River Wall Liaison Summary Note

Stag Brewery

Client Name: Reselton Properties

Document Reference: WIE15582-106-BN-1-2-1-EA

Drawing title
Development Area 1 Flood Defence Plan

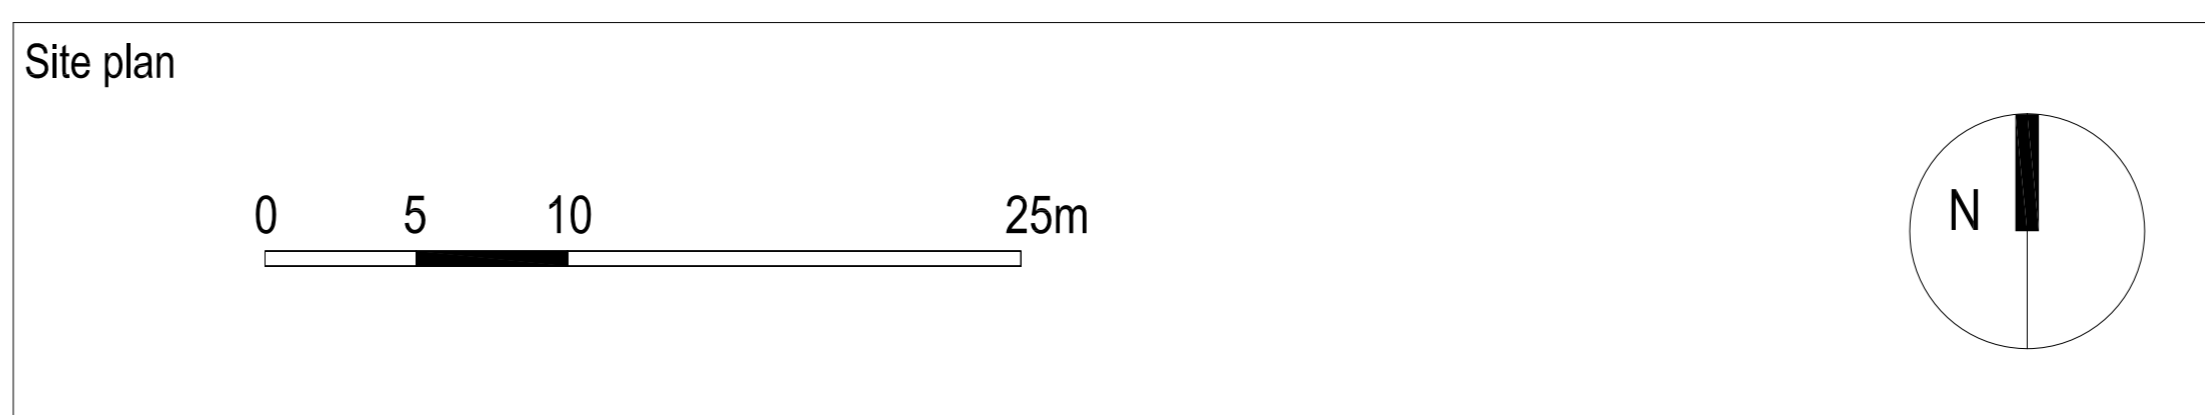
Query 5) – *The FRA includes reference to a minimum of 4m clear access route. Is the 4m between the new flood defences and development? Site Plans are also required clearly outlining the exact location of the new defence line including access arrangements and distances. It is also not clear what is being proposed for Ship Lane and Bull Lane. Details of the proposed flood gate barriers should be provided.*

Response – Please refer to the enclosed plan and sections prepared by Gillespies (Appendix A) which show the 4m minimum clear access route and offsets to defences.

In addition to the above, the lobby/entrance area of the boat house would be raised to 6.7m AOD as per drawing P10736-00-001-116-D02 and the hand sketch submitted with the previous response, these drawings are included in Appendix A.

Drawing:
BUILDING 09 - PROPOSED GROUND
FLOOR PLAN

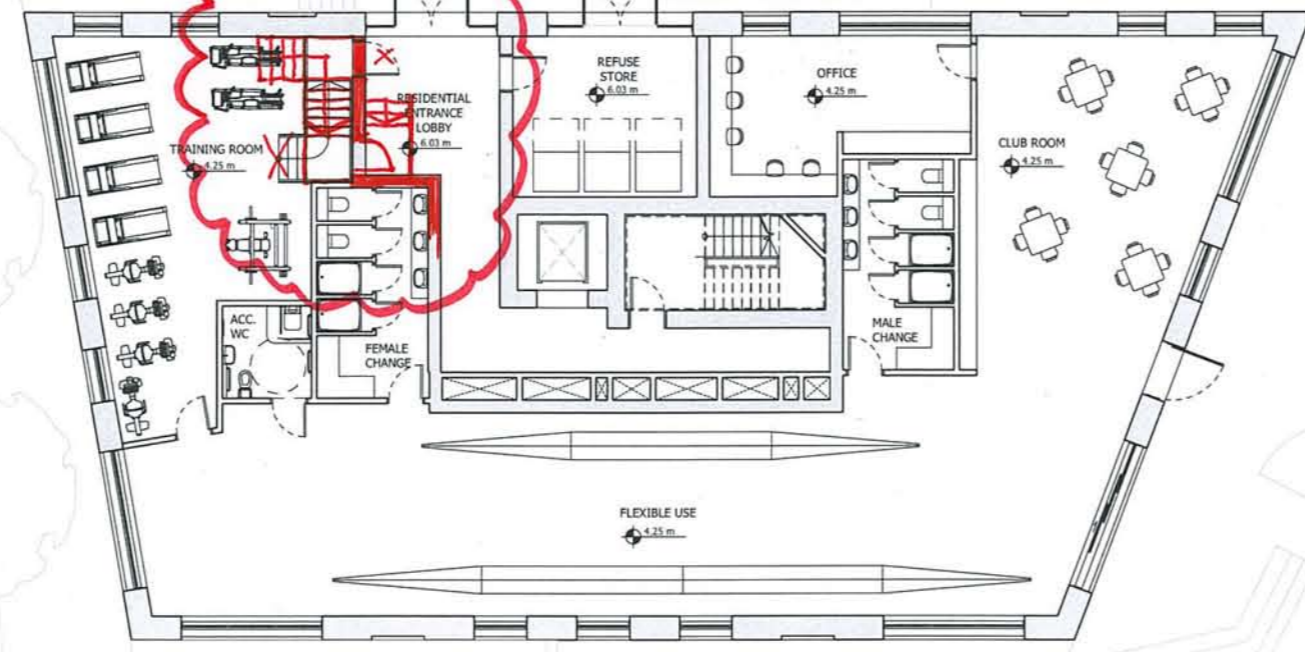
Drawing 38262/5501/062 illustrates the boathouse building on the eastern end of the site incorporates windows and internal access point below the TE2100 level within the flood defence line. The finished floor levels in the lobby/entrance area of the boat house are proposed to be set at 6.03m AOD, but the boat house finished floor level is to be set at 4.25mAOD. Details of how access will be achieved from the landward side of the flood defences into the boathouse will need to be provided.

AMENDMENT
TO ESCAPE STEPS FROM
BOAT CLUB, THROUGH
RESIDENTIAL ENTRANCE
LOBBY. TOP LANDING AT
ESCAPE DOOR TO BE RAISED
TO 6.7M A.O.D.

| Drawing Number 38262/5501/062 | Revision K | |

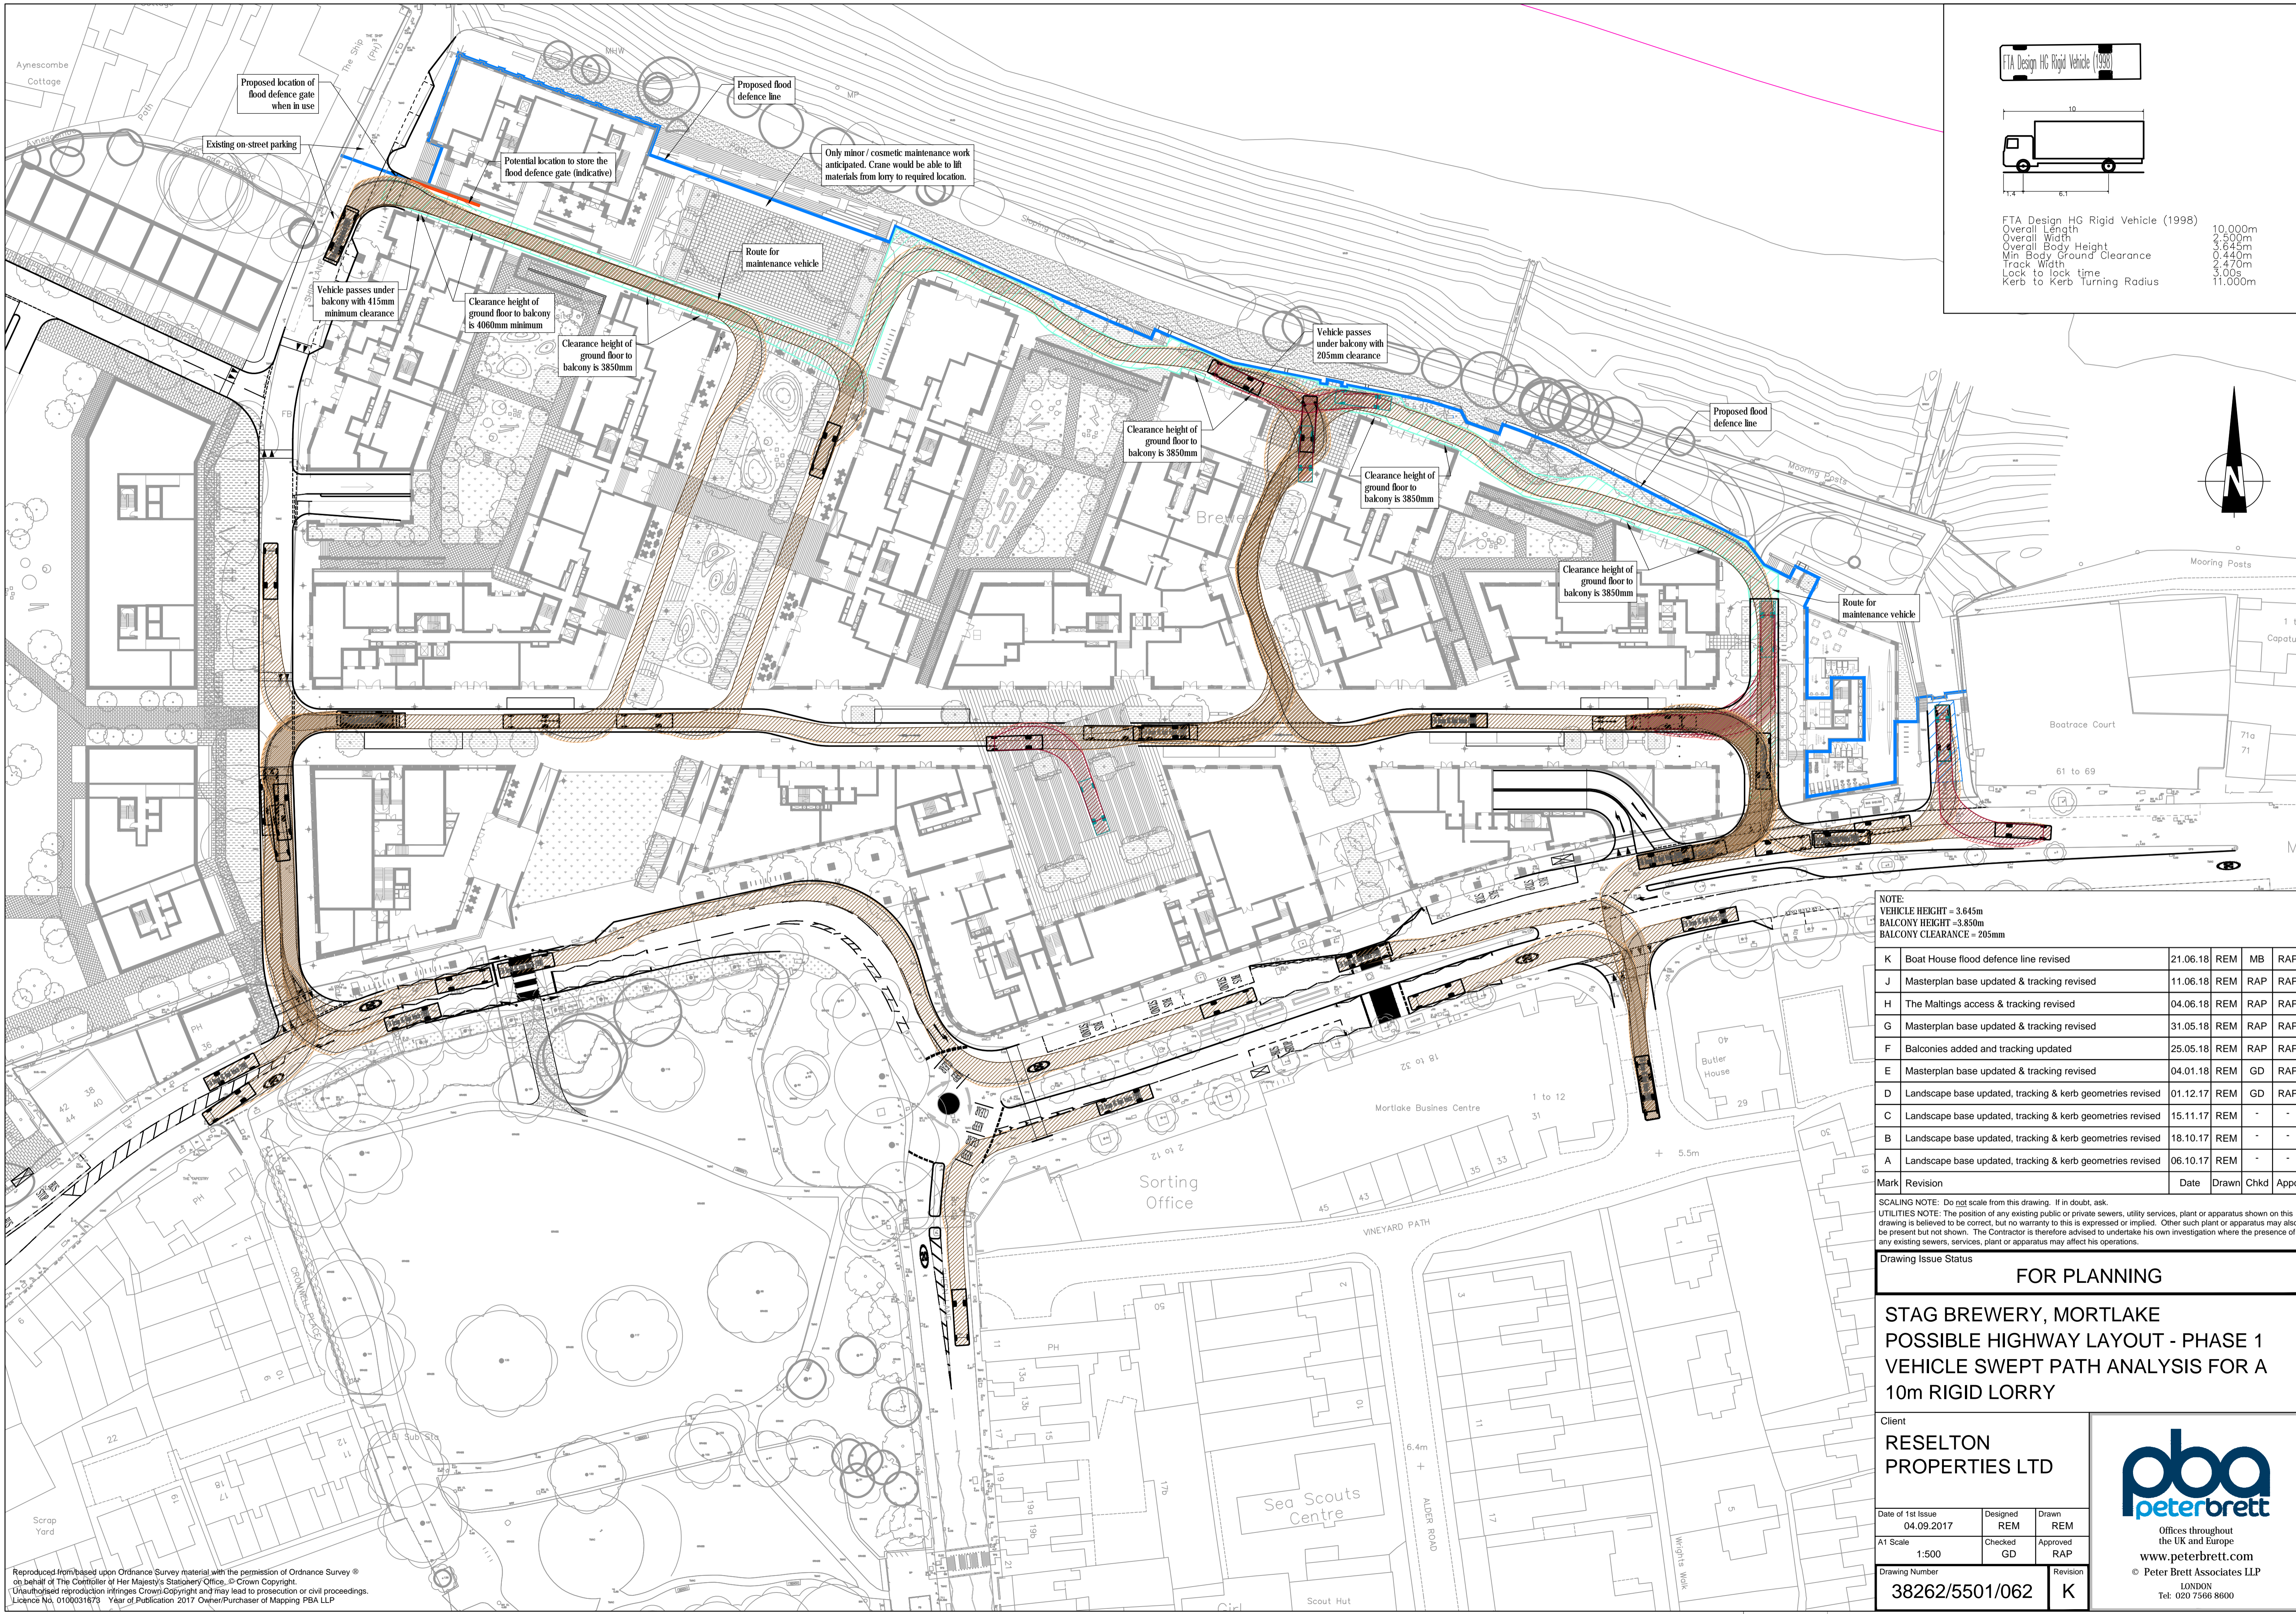
Drawing 38262/5501/062 illustrates the boathouse building on the eastern end of the site incorporates windows and internal access point below the TE2100 level within the flood defence line. The finished floor levels in the lobby/entrance area of the boat house are proposed to be set at 6.03m AOD, but the boat house finished floor level is to be set at 4.25m AOD. Details of how access will be achieved from the landward side of the flood defences into the boathouse will need to be provided

Drawing 38262/5501/062 illustrates a vehicle tracking plan for a 10m long lorry, however the circa 4m clearance height appears to be insufficient to actually operate any plant within these areas. Furthermore, the flood defence within the northwest corner of the site appears to be inaccessible. It appears that the applicant will use of the existing building as the defence line. Further information is required as to how the defence will be accessed from the landward side.

Query 4) – Vehicle tracking plan – Drawing 38262/5501/062 illustrates a vehicle tracking plan for a 10m long lorry, however the circa 4m clearance height appears to be insufficient to actually operate any plant within these areas. Furthermore, the flood defence within the northwest corner of the site appears to be inaccessible. It appears that the applicant will use of the existing building as the defence line. Further information is required as to how the defence will be accessed from the landward side.

Response – As set out in the previous response dated 27th June 2018 (Appendix A), the tracking accounts for vertical clearance to balconies and trees, ensuring that vehicles can pass beneath unrestricted. Drawings 38262/5501/091/D and 38262/5501/062/K (Appendix A) show that the vertical constraints are only present in a limited number of locations and that there are only two locations where the 10m Rigid Vehicle needs to pass under a balcony. In the west of the site one balcony overhangs the tracked vehicle path by a maximum of approximately 360mm. In the east of the site the balcony would only overhang the tracked vehicle path during a three-point turn manoeuvre by a maximum of 670mm. Given the overhangs are so small, vehicles or plant would easily be able to manoeuvre around these overhangs and operate effectively, this is considered acceptable.

As set out in the previous response the area to the south of the proposed flood defence and to the east of the Maltings Building would not allow vehicles to park directly adjacent to the defence. However, a crane could be used to move maintenance materials to the required location. Furthermore, due to the proposed piled construction of the defence it is anticipated that any maintenance would be minor or superficial. In the highly unlikely scenario that vehicle access is required to this area a temporary ramp could be constructed to bypass the steps.
